DOE Comments to ExxonMobil's Responses (and the Attached Proposed Work Plan) to NRC's Request for Additional Information Regarding the *Highland Uranium Mine and Millsite Request for Amendment to Radioactive Materials License SUA-1139; Application to Amend Existing Alternate Concentration Limits* (and Proposal to Include the "Pit Lake" within the Long-Term Surveillance Boundary)

The purpose of this review, performed at the request of the U.S. Nuclear Regulatory Commission (NRC), is to provide comments on ExxonMobil Environmental Services Company's (EMES) responses to NRC's Request for Additional Information (RAIs), dated April 12, 2013, and its attached proposed work plan titled *Highland Mine & Millsite Supplemental Hydrologic and Geochemical Characterization Work Plan* (work plan). NRC developed the RAIs in response to EMES's May 2011 license amendment request titled *Highland Uranium Mine and Millsite Request for Amendment to Radioactive Materials License SUA-1139; Application to Amend Existing Alternate Concentration Limits* (ACL application), which includes a proposal to include the incompletely reclaimed and contaminated former open pit uranium mine, referred to as the "pit

Trend Graphs

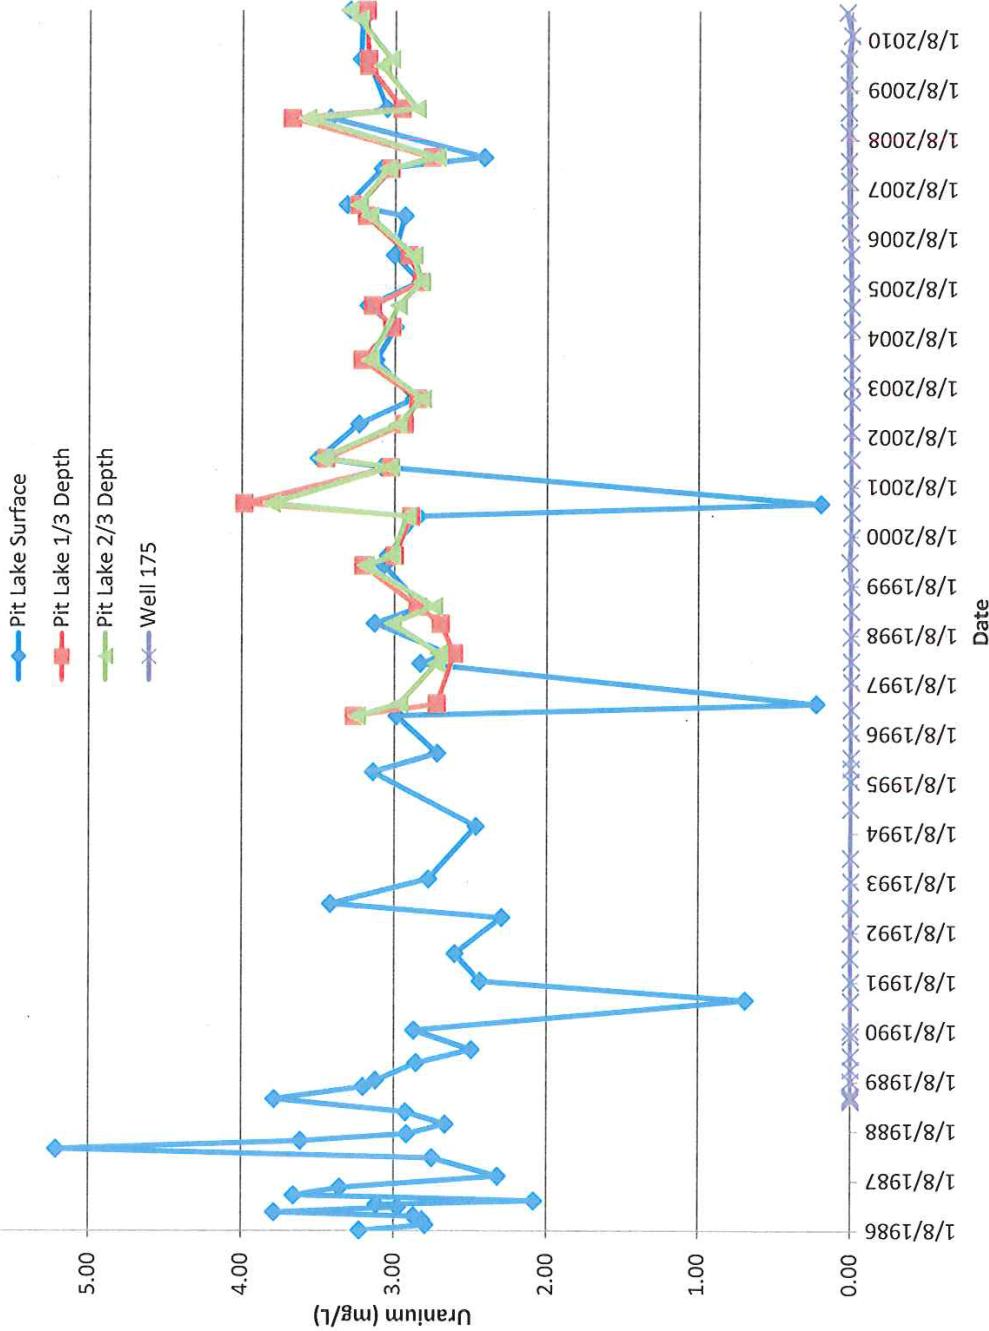
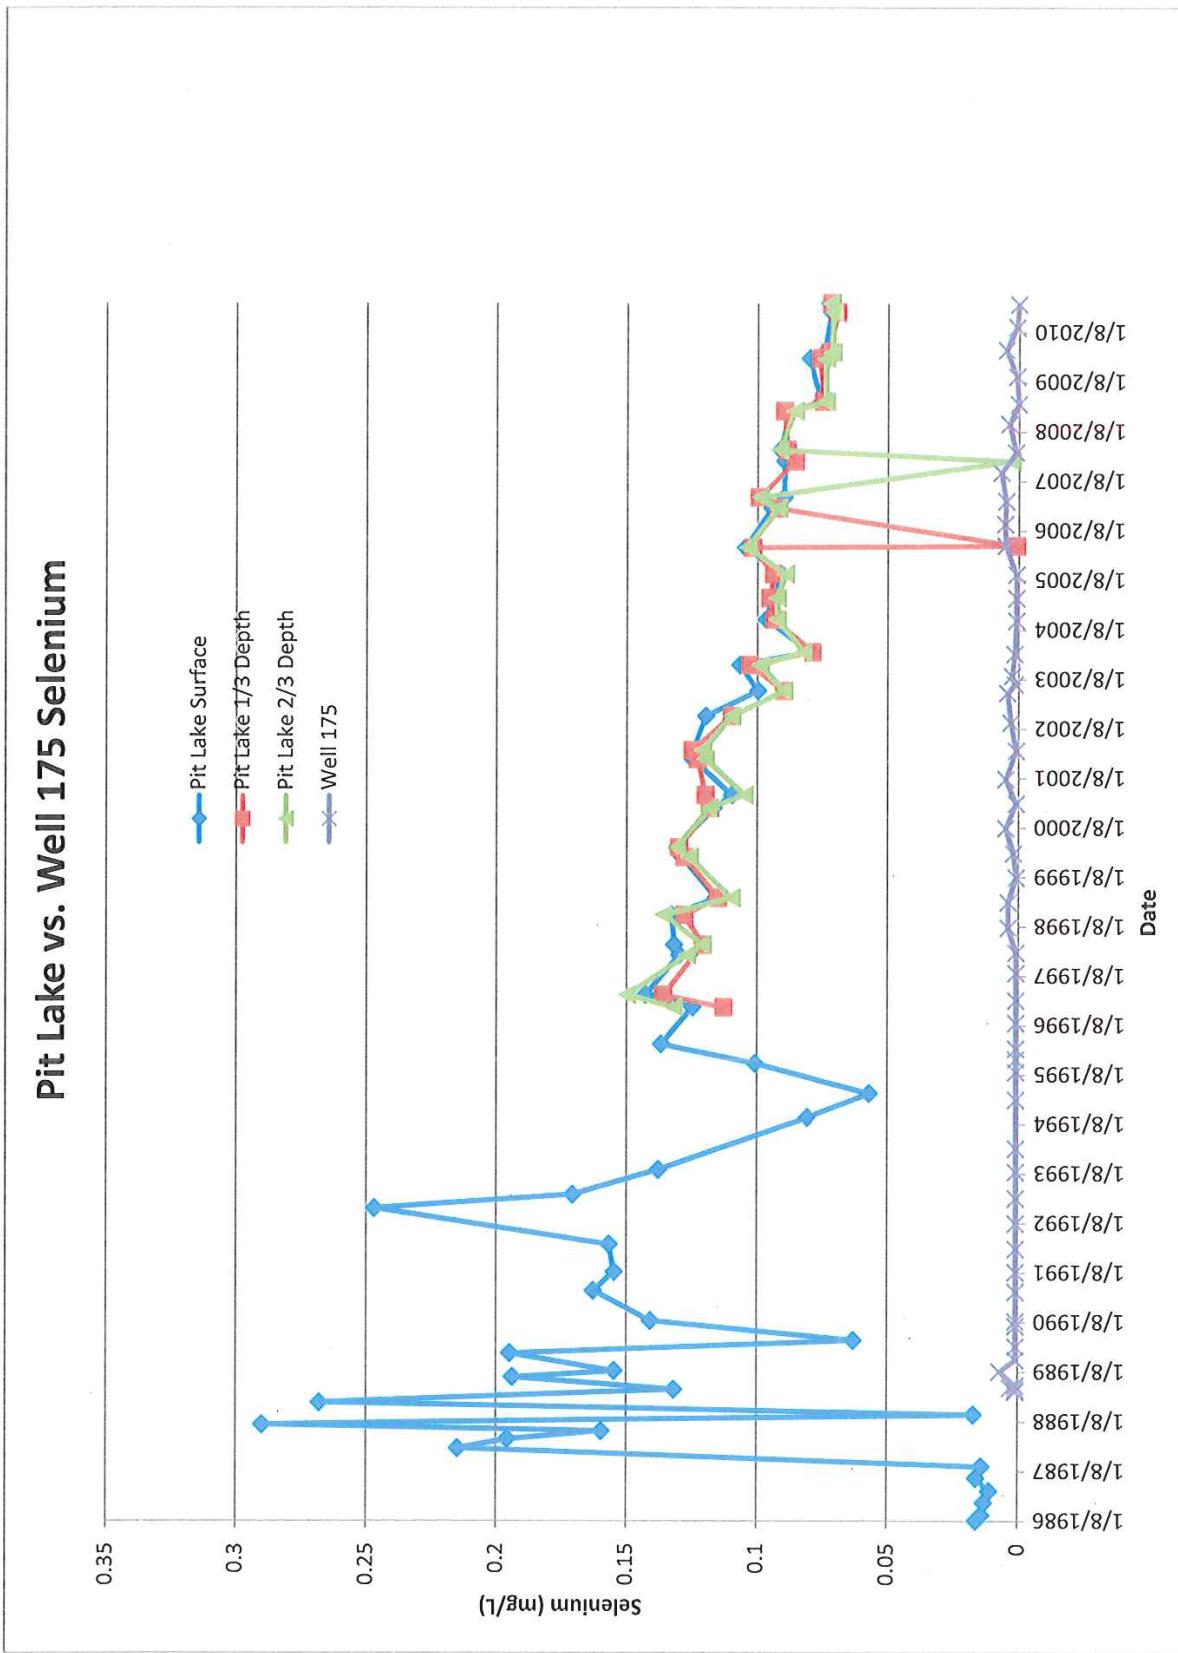
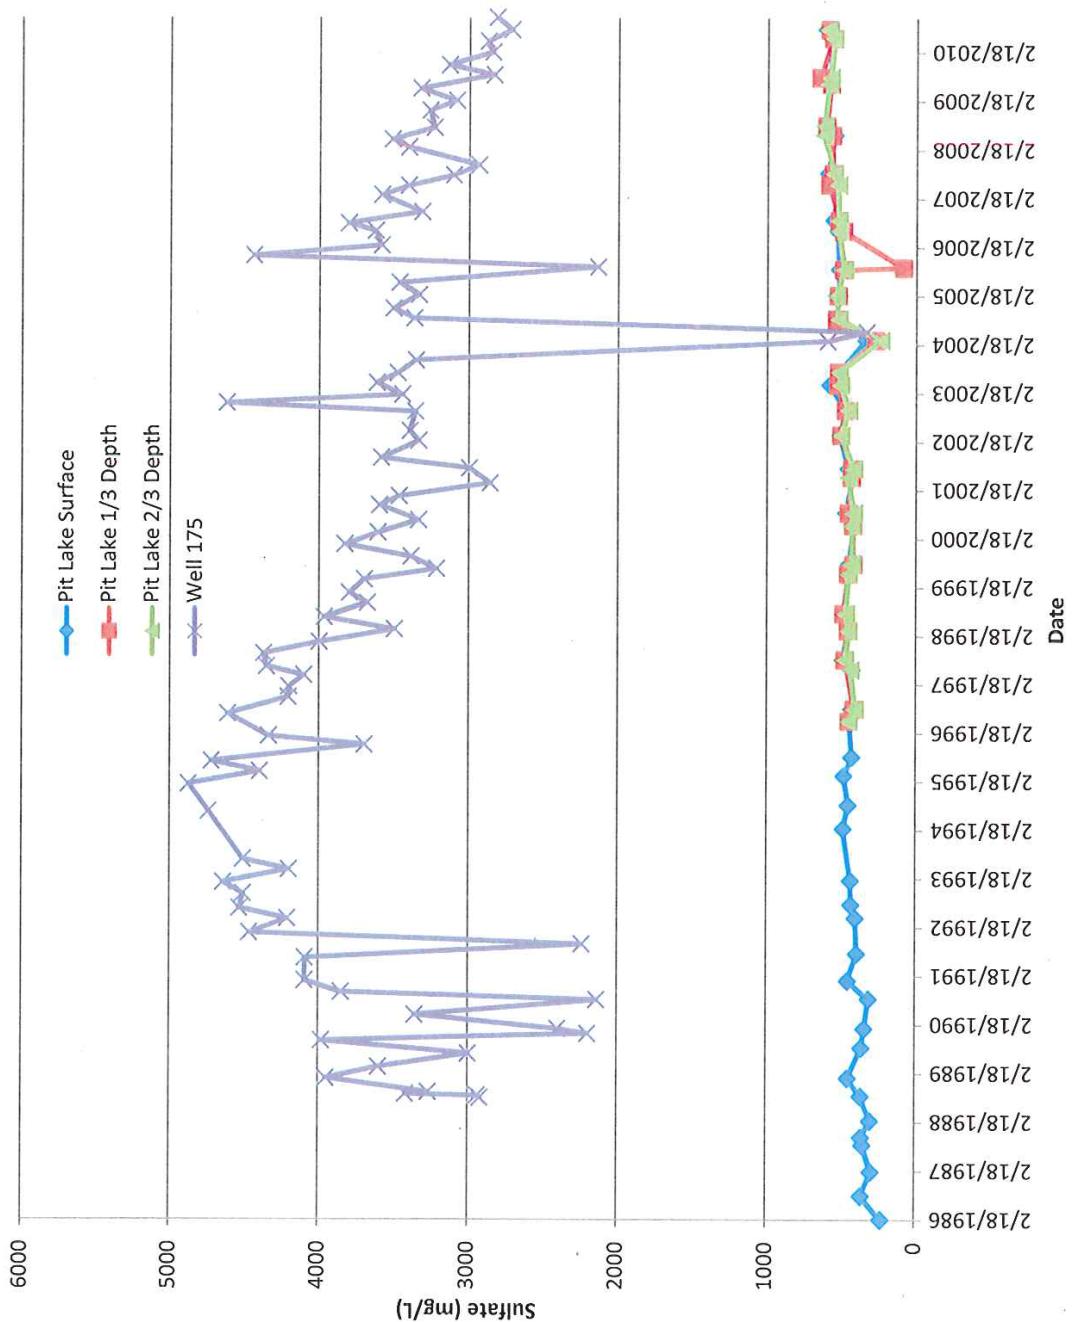
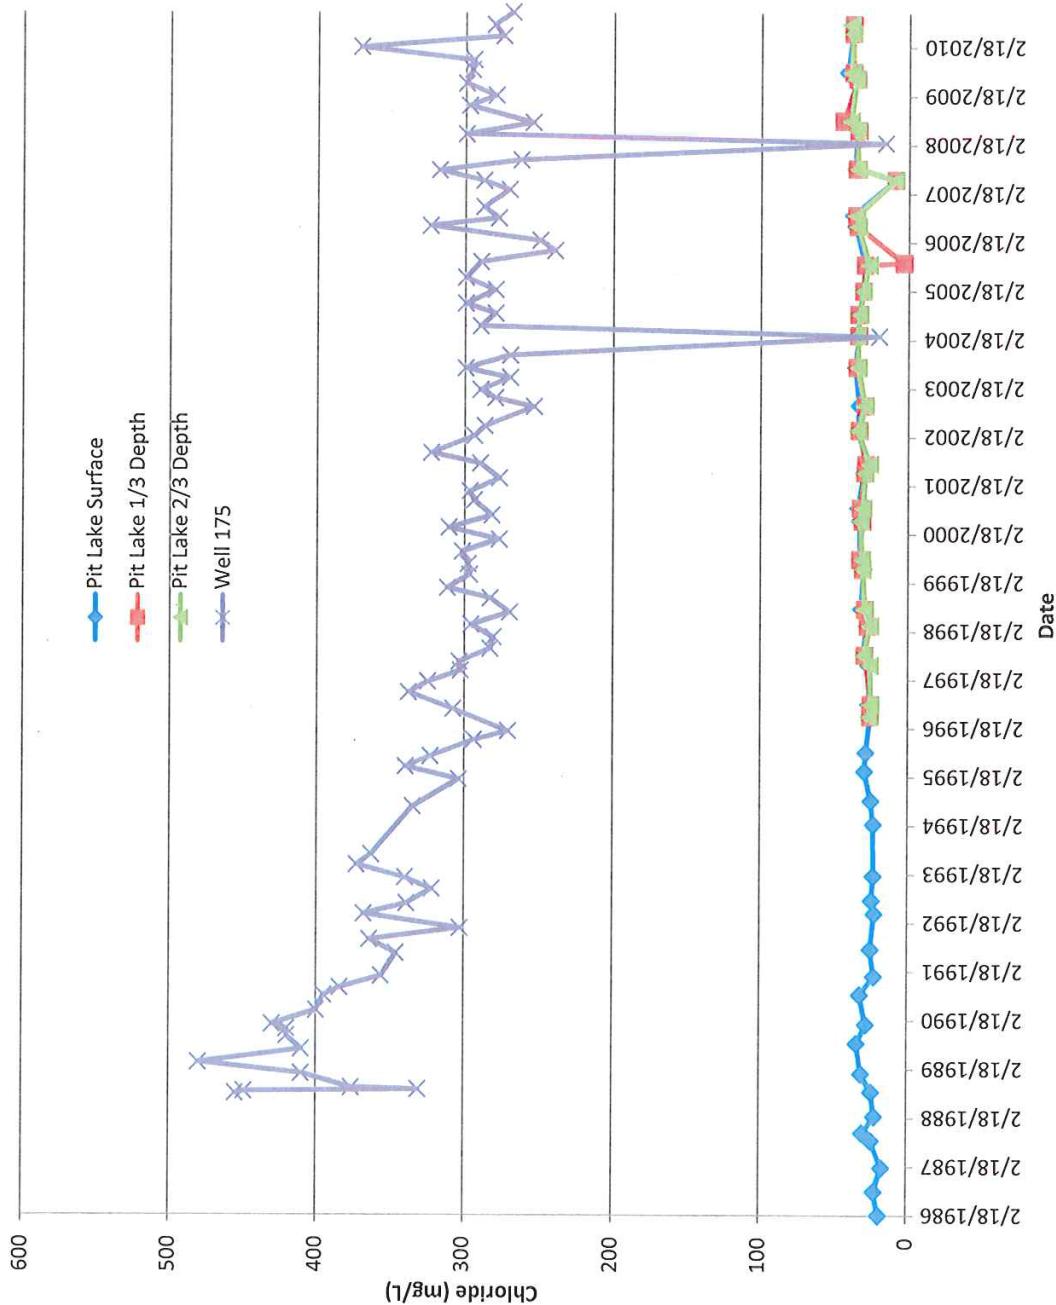
- Only a small portion of the TDSS was actually in direct contact with the tailings.
- No concentrations of uranium in groundwater have been observed that approach that of the pit lake (around 3 mg/L) let alone that observed in tailings fluids (up to 13 mg/L). POC well 175 uranium concentrations have remained less than the 0.03 mg/L standard for over 20 years and have only recently had one exception—the 0.0381 mg/L result in August 2010 (see Attachment 1 trend graphs).

- $^{234}\text{U}/^{238}\text{U}$ ratios observed in the pit lake are used as evidence that the uranium is most likely milling-related, with ratios close to 1.0. However, it has been demonstrated that leaching of uranium ore bodies under oxidizing conditions also produces high concentrations of uranium with $^{234}\text{U}/^{238}\text{U}$ ratios close to unity (Caine et al. 2011)⁷. This interpretation is consistent with the originally proposed model for pit lake water quality and appears to be validated by over 20 years of monitoring data (see Attachment 1 trend graphs).

Figure 1. Tailings flux values from Tetra Tech (2007a) and Tetra Tech (2007b).

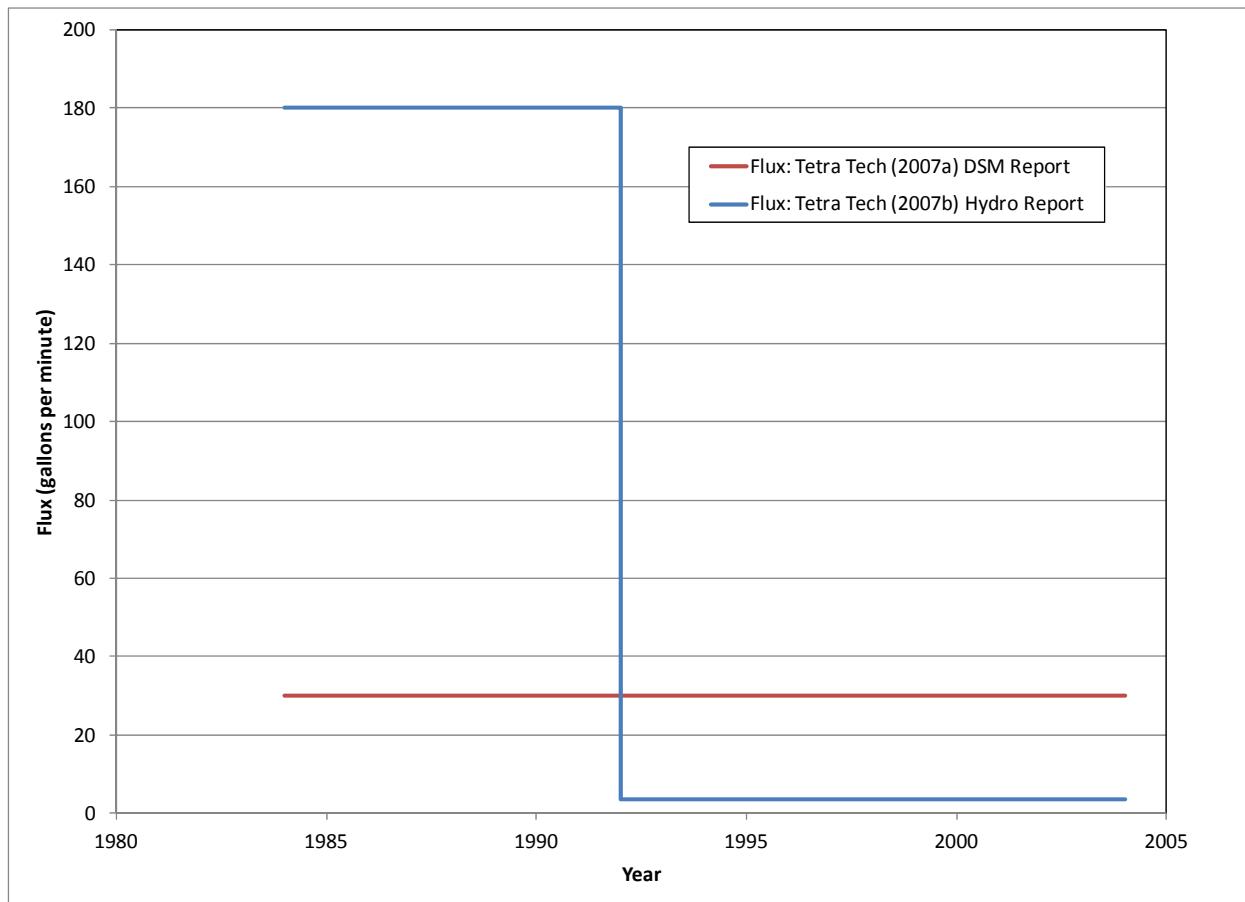
Based on this statement it is unclear how the flux value of 30 gpm for 20 years was selected. The quoted maximum, 180 gpm, is a total flux from the tailings, not necessarily that which was believed to have entered the pit lake, and by 1992, eight years later, this flux purportedly had decreased to 3.5 gpm. The value of 30 gpm for 20 years does not appear to be a conservative estimate of flux entering the pit lake, but rather a maximum flux, see Figure 1.

A cursory examination of the Tetra Tech (2007b) report, *Long Term Pit Lake and Groundwater Hydrology at the Highland Mine Site*, seems to show inconsistencies in the flux values used in the DSM compared with those in the hydrology report. A detailed critical review of the hydrology and DSM should be carried out to determine if the steady-state values used in the DSM are consistent with the transient flux values of the hydrologic model.
